Supplemental Information: Grand Gulf Early Site Permit, SSAR Section 2.2, Nearby Industrial, Military and Transportation Facilities and Routes

NRC Staff Clarification Questions

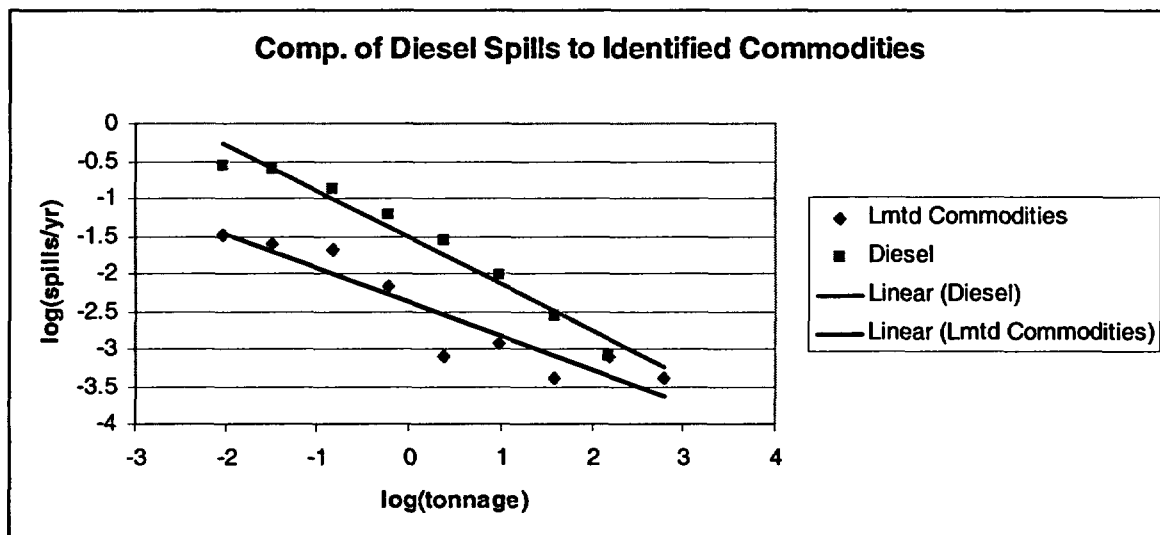
4. Page 22, 2.1 Spill Frequency Assessment: What is the basis for excluding spills involving commodities such as chlorine, coconut oil, diesel, lubricating oil ,etc? It is reasonable to expect a spill being the result of some sort of loss of tankage integrity (e.g., puncture, rupture). Hence, there is no apparent functional relationship between the type of commodity and the initiation of a spill in the event of a barge mishap. Exclusion of spills on the basis of commodity type can lead to a significant underestimating of the spill frequency.

in the RAI Response text (Section H). If the total number of spills in each bin is ten times greater, then the curve fit will be an order of magnitude greater ($f = 10 \cdot 10^{0.4871 \cdot \text{LOG}(\text{tonnage}) - 2.7457}$). But then, when determining the fraction of spills that are one of the critical commodities, a multiplication factor of 1/10 would be applied, providing the same equation, $f = 10^{(-0.4871 \cdot \text{LOG}(\text{tonnage}) - 2.7457)}$ again.

Of course, the new spills may not increase each bin total by an identical ratio. If the new spills tended to be of a smaller size, they would tilt the curve fit such that it would have a more negative slope. Evaluation of diesel spills (all spills in the MistlePoll database identified as diesel, some 2102 spills), show this is the case. A plot of curve fits to diesel spills and to the commodities previously identified is shown below. Since the diesel curve fit is steeper, it would be non-conservative to include diesel spills.
